Transport – The A449

Issue 1: The 1.8km section of the A449 immediately to the north of J2-M54 is missing from the Applicant's Appendix 11.5 data/analysis.

Figure 1: The image shows the Applicant's route analysis from its current Transport Assessment. The geographically more direct and shorter routes offered by the A449-WMI link Road-A5 compared to that offered by the proposed scheme is absent from the Applicant's analysis.

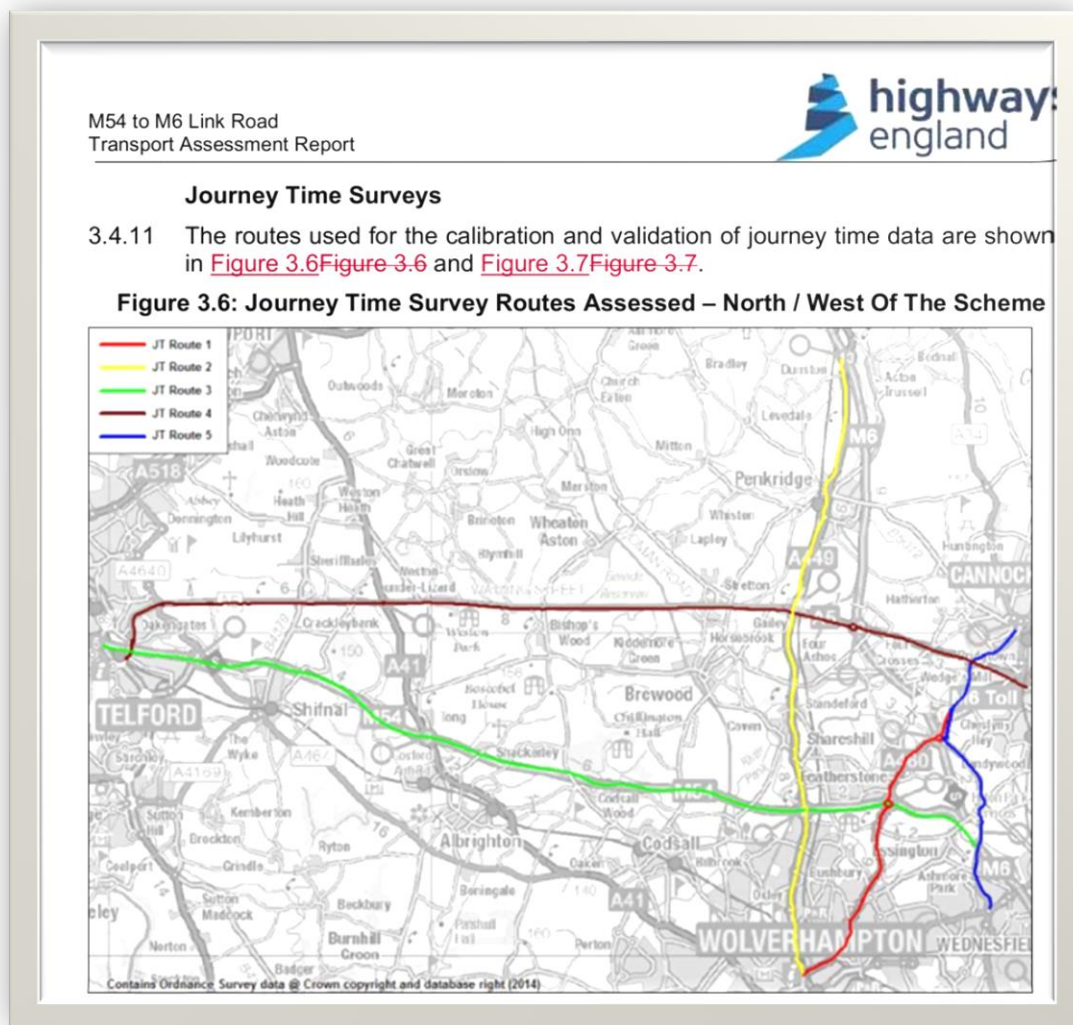
The Applicant has not provided journey time data that explains how long a journey would take using the A449-West Midlands Interchange (WMI) Link Road³-A5 route between M54-J2 and J12-M6 (and vice versa) compared to the time it would take to use the route that is offered by the proposed DCO. Figure 1 below shows the way in which the Applicant is trying to frame their analysis away from a direct scrutiny of the A449-WMI Link Road-A5 route.

Question 5: Could the Applicant please provide clear, unambiguous data so we can see the full extent of the journey time benefits offered by the proposed scheme? I would like to see the journey times from J2-M54 to J12-M6 in a simple two column table so that the two routes can be compared and contrasted.

KETTLE HOLES SOUTH EAST
OF LAPLEY (ST19 5QJ)

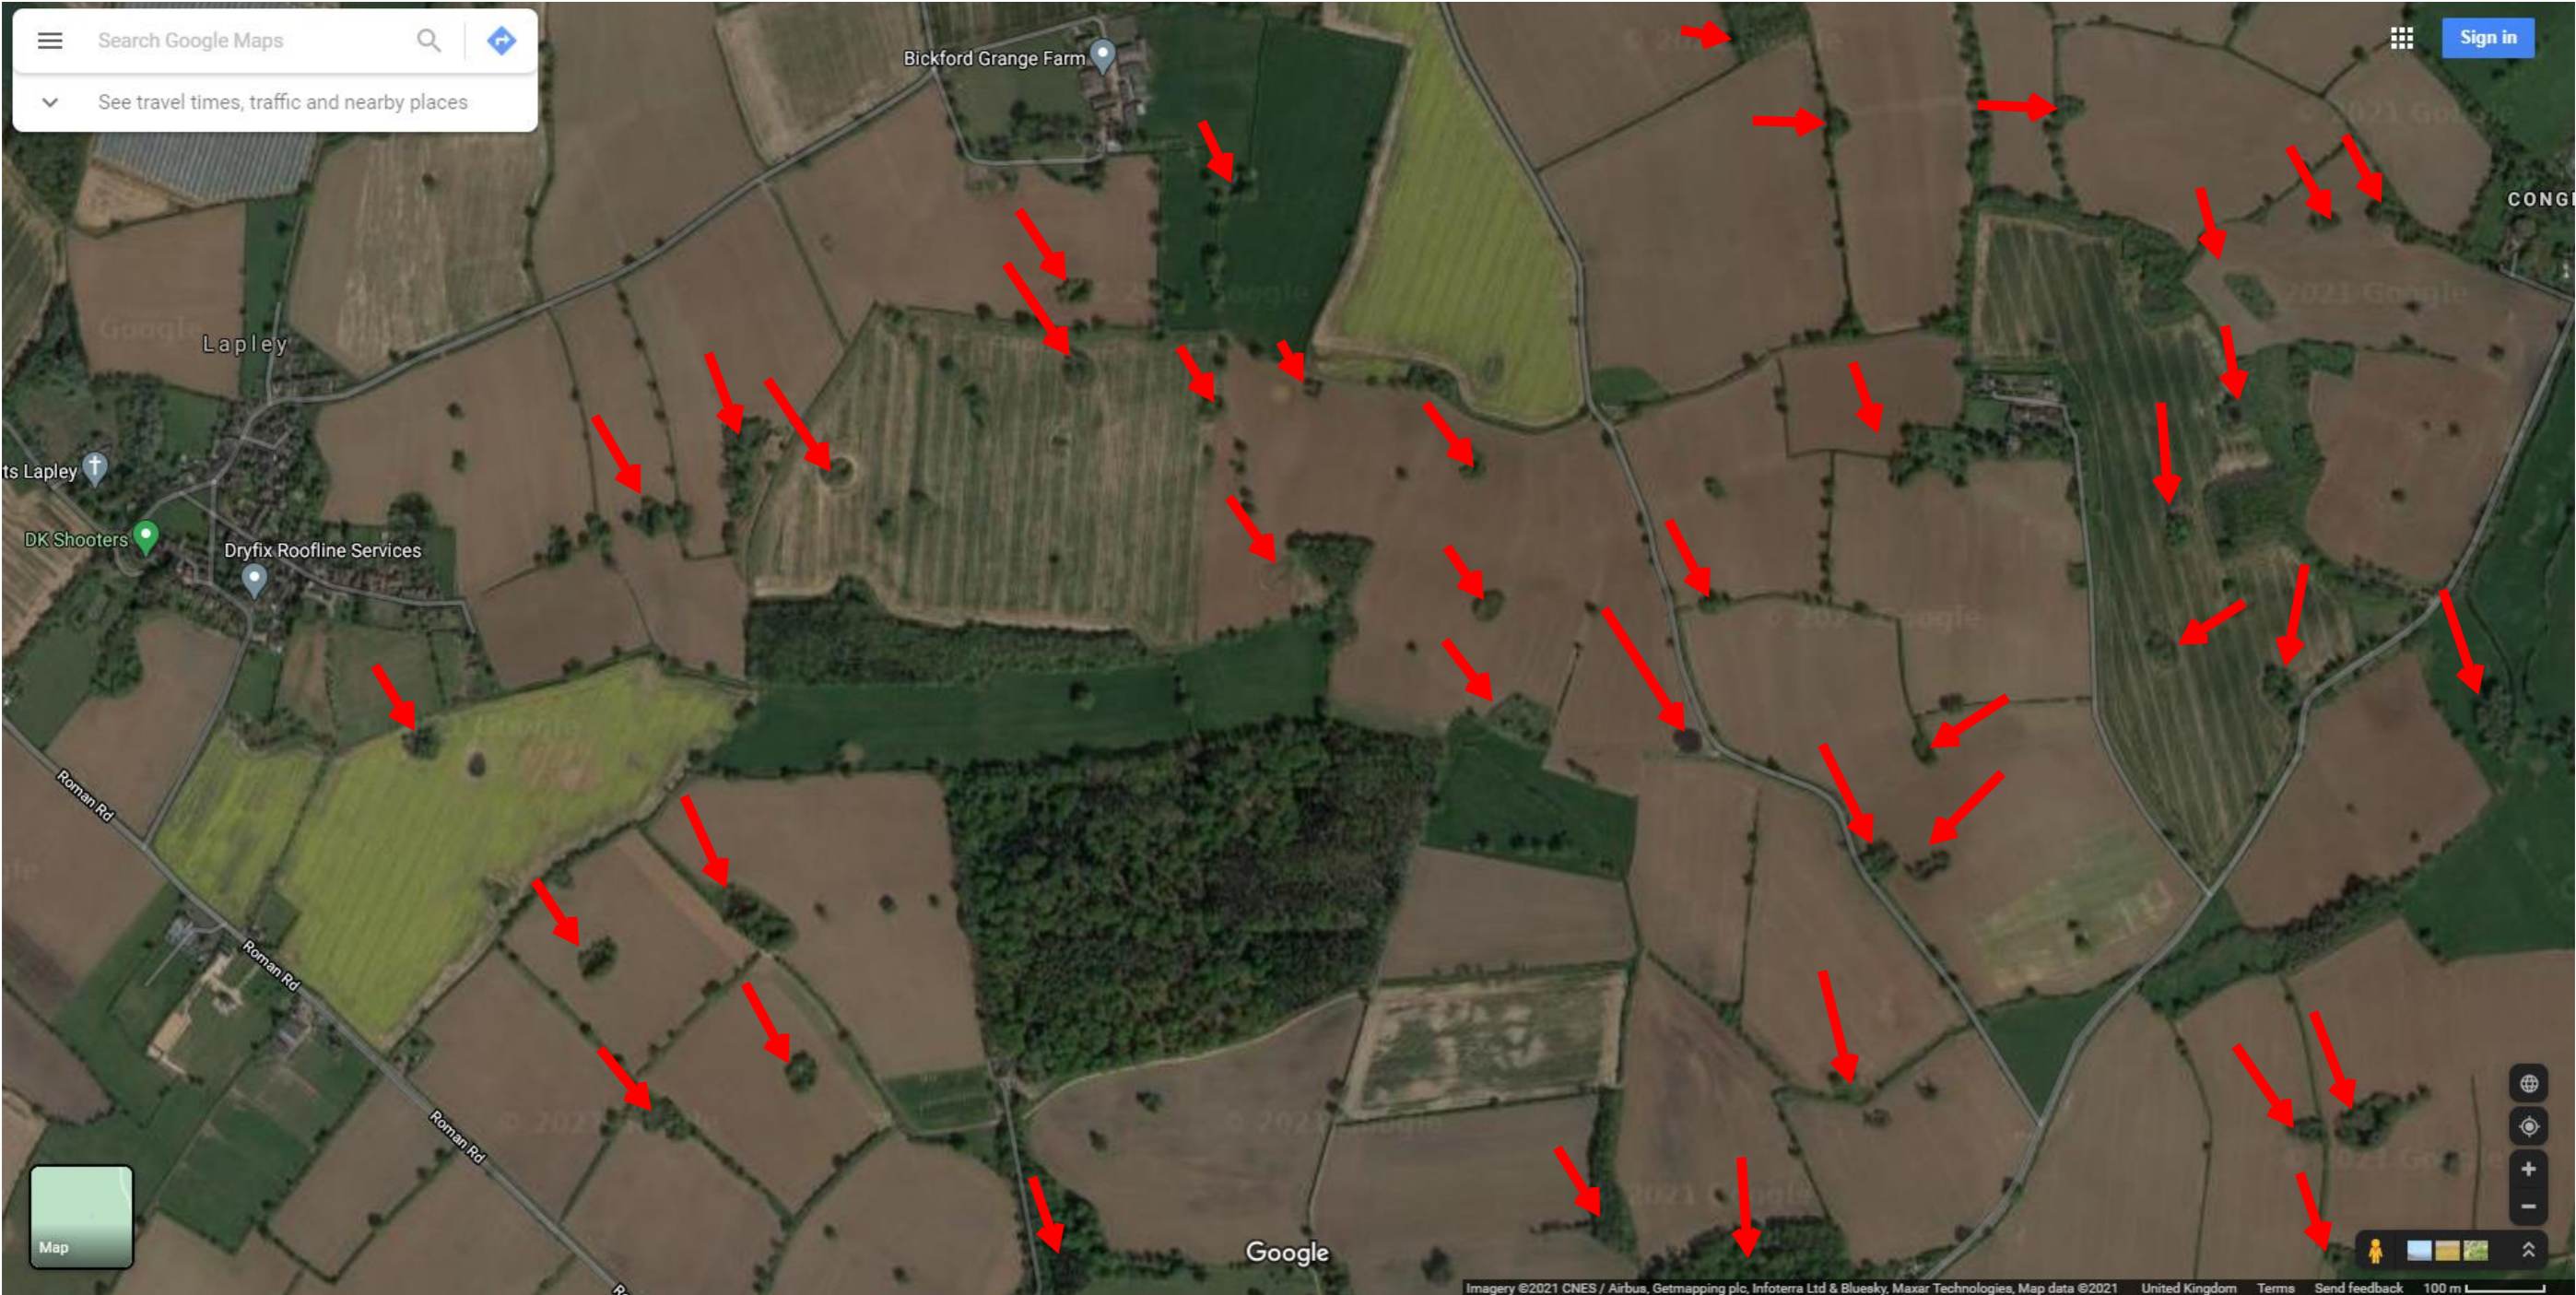
Using Google Earth, I would invite the Applicant and the ExA to look at the landscape around Bickford Grange Farm near the settlement of Lapley (Postcode ST19 5QJ). This area contains one of the densest concentrations of Kettle Holes in Britain (please see Appendix 2). The 6-7km space between that dense concentration and the site itself is still heavily peppered with Kettle Holes. These features are not widely recognised or documented by any scientific literature that I am aware of; it is an open research gap which needs plugging as a matter of urgency. I agree with the Applicant that many geomorphic features within or adjacent to the Order limits may turn out not to be Kettle Holes but there are always exceptions which need to be found, documented, and analysed for paleoenvironmental proxies.

- More detailed review of the main body of sheet 153⁷ identifies that the site crosses an expanse of Late Devensian Till. This is exactly the type of terrain in which Kettle Holes form. I would invite the ExA to look at the geology of site, the geology of the area to the south east of Lapley (Postcode ST19 5QJ) on sheet 153 and the features identified in the aerial imagery given in Appendix 2.
